CERTIFICATE OF APPROPRIATENESS

Property: 321 Heights Boulevard, Lot 4 and Tract 5, Block 313, Houston Heights Subdivision. The property consists of two lots – Lot 4 is 7500 sq ft (50' x 150') and is developed only with a concrete parking pad. Tract 5 is 7450 sq ft corner lot containing a historic 2,751 square foot two-story wood frame single-family residence. The owner is proposing to build the new structure on Lot 4.

Proposal: New Construction – Construct a two-story 1,308 square foot residence and integrated two-car garage.

321 Heights Boulevard – New Construction/Garage Resubmittal

EAST ELEVATION – FRONT FACING HEIGHTS BOULEVARD

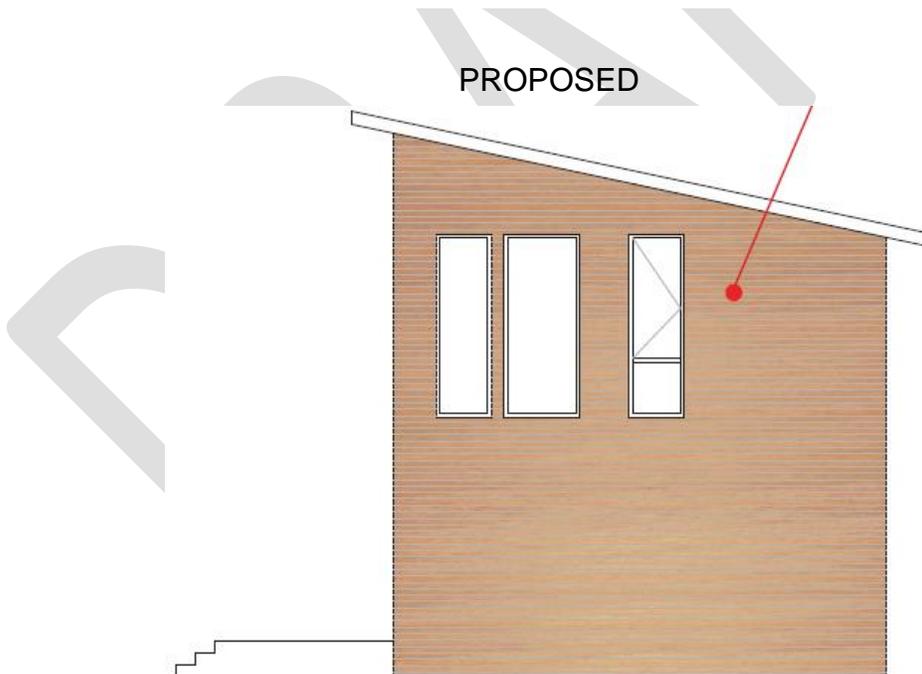
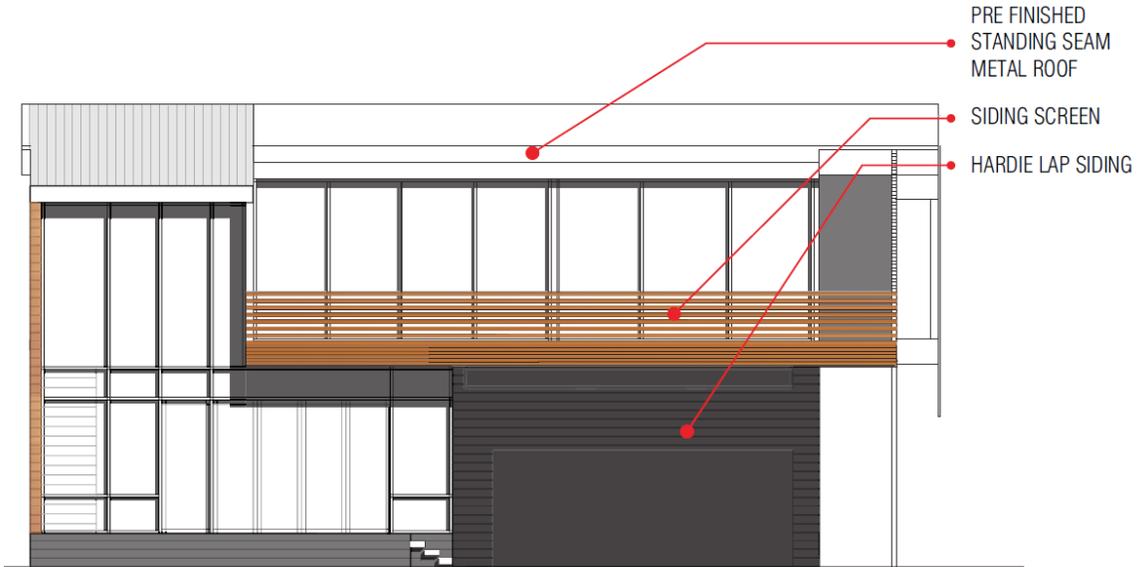
(East) The first-story of the proposed front elevation will have no fenestration on the northern portion while the southern portion will have a pair of windows. The second-story will have no fenestration on the northern portion while the southern portion will have a four floor to ceiling windows. The second-story windows will be partially obscured by the proposed siding screen. A second story deck extends to wrap the southern corner and extend along a portion of the façade.

August 2015:

The front elevation of the proposed structure will have no fenestration on the first story. The second story will be comprised of three large vertical windows. The structure will be topped with a shed roof sloping down towards the northern property line. See drawings for more detail.

Does Not Meet Approval Criteria #2 – The exterior features of the proposed new construction are not compatible with the exterior features of existing contributing structures in the HSHD. An example of exterior features of existing contributing structures in the HSHD can be found on the adjacent contributing structure. These existing exterior features include: Triangular bordered front gable, covered front porch with round full-height columns, triple bay double hung one-over-one windows, foundation banding and fascia banding on a one-story structure. The proposed structure includes cedar lap siding and fixed pane windows, neither of which are typical exterior features of existing contributing structures in the HSHD.

SOUTH SIDE ELEVATION

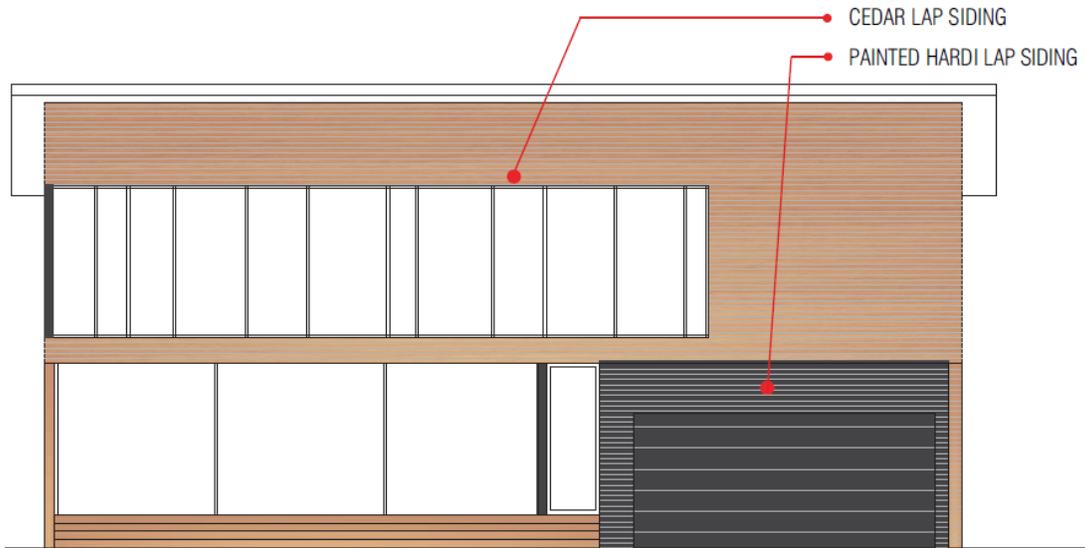
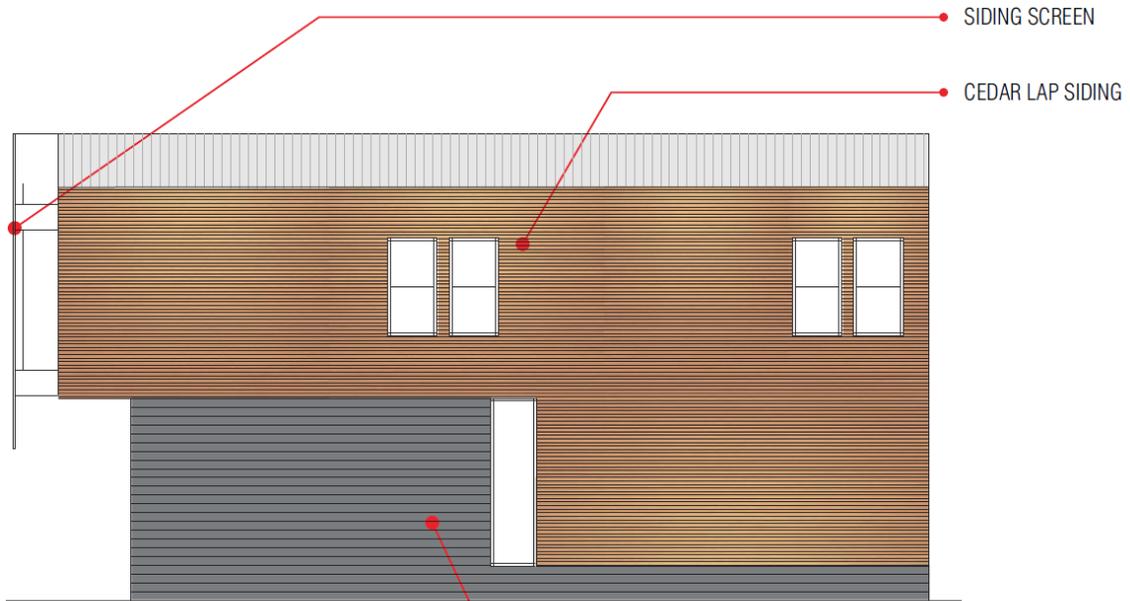
(South) The first-story of the proposed south elevation has the garage door located at the eastern portion while a glass wall spans the western portion. A deck spans the front three-quarters of the second-story. A glass window and door system spans this same area. To the rear, windows from the first-story extend up to the roof.

The proposed garage is located on the eastern portion of the south elevation. The remainder of first story is comprised of three large glass windows and door. On the second-story, the area above the garage door features no fenestration while the remaining area consists of a series of windows. See drawings for more detail.

NORTH SIDE ELEVATION

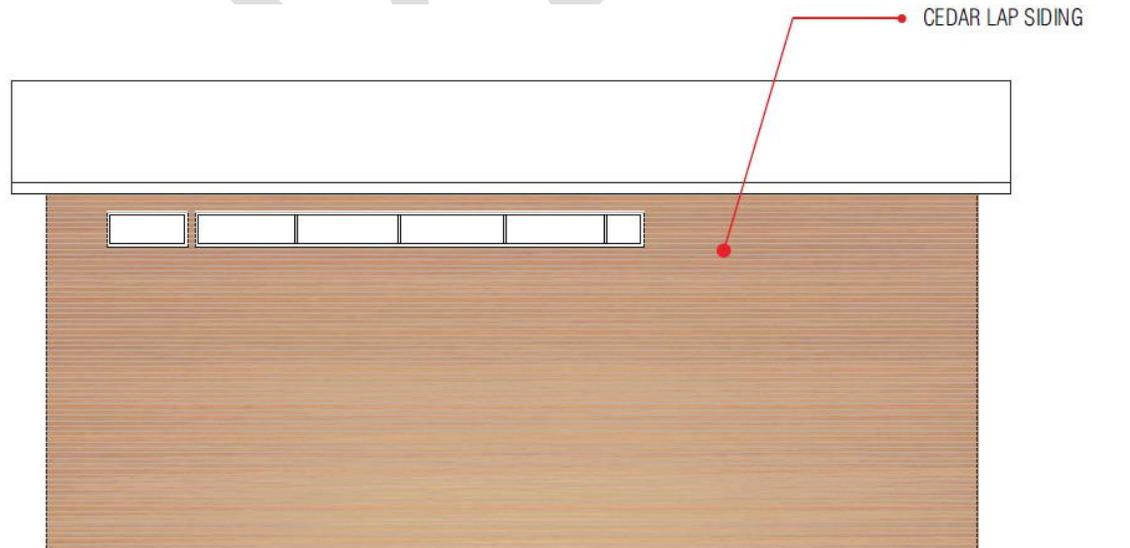
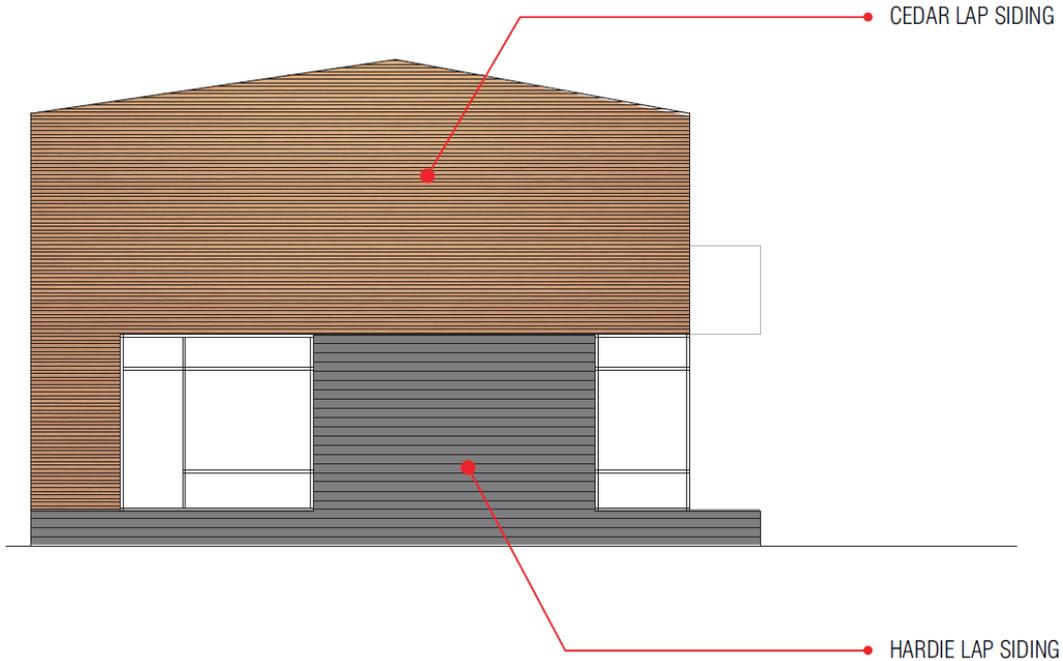
(North) The proposed north elevation has a single vertical window on the first-story and four 1-over-1 windows on the second-story.

The north elevation contains no fenestration on the first-story. The second-story has six horizontally oriented windows. See drawings for more detail.

SITE PLAN
DENIED MAY 2015

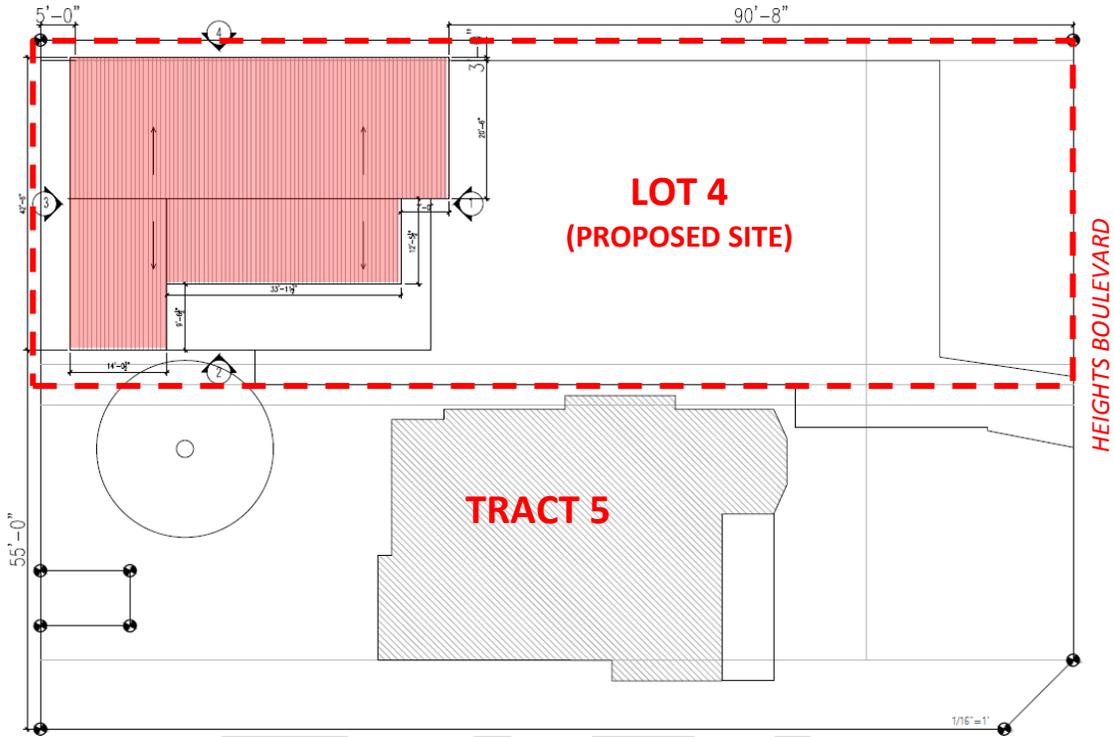
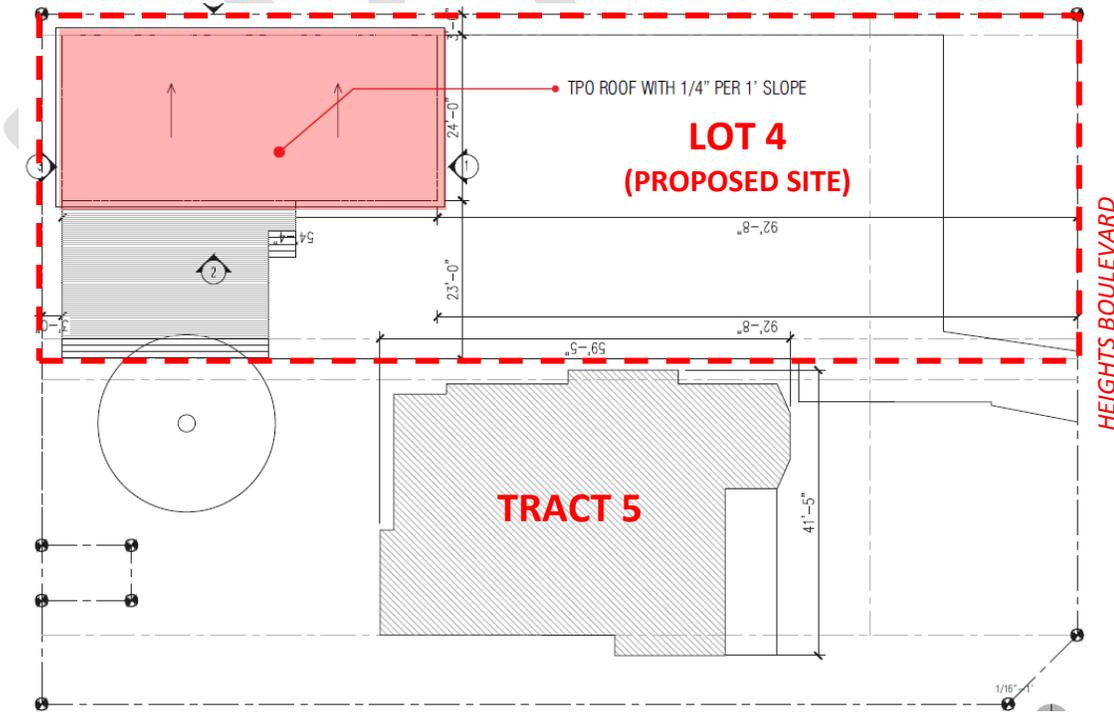
The proposed residence and garage will have a front (east) setback of 90'-8" (to the second-story screen); a south side setback of 5'-0" from the southern lot line of Lot 4 (55'-0" from the southernmost portion of Tract 5); a north side setback of 3'-0"; and a rear (west) setback of 5'-0".

The proposed residence and garage will have an east (front) setback of 92'-8"; a north side setback of 3'-0"; a south side setback of 23'-0" (73'-0" to the southernmost portion of Tract 5); and a west (rear) setback of 3'-0". See drawings for more detail.

Does Not Meet Approval Criteria #1 - The proposed new construction does not match the typical setbacks of existing contributing structures in the historic district. The new construction is proposed to be placed 92.8 feet from the front property line. This is significantly greater than the typical front setback line within the HSHD. In fact, the adjacent contributing structure is significantly closer to the front setback line than the distance proposed for the new construction. Greater setback lines along Heights Boulevard would substantially reduce the historic character of the HSHD. The proposed construction should be placed approximately in line with the existing adjacent contributing structure.

ROOF PLAN
DENIED MAY 2015

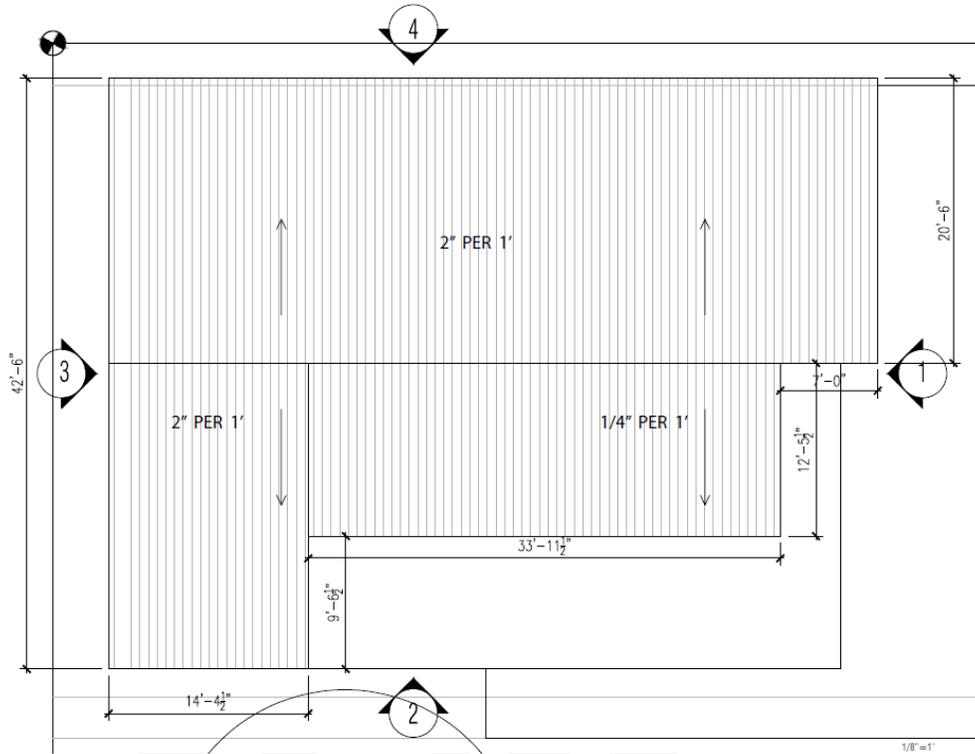
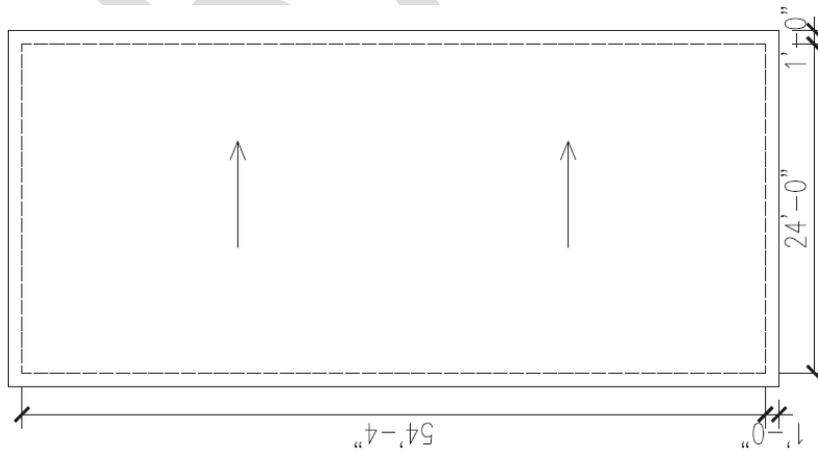
Does Not Meet Approval Criteria #3 – The roofline of the proposed new construction is a basically flat, minimum slope membrane roof which is not compatible with rooflines and resulting typical proportions of existing contributing structures in the HSHD which generally have sloped roofs in the 5:12 or 6:12 angle proportion. A typical example would be the adjacent existing contributing structure which has a sloped roof that is typically found in the HSHD.
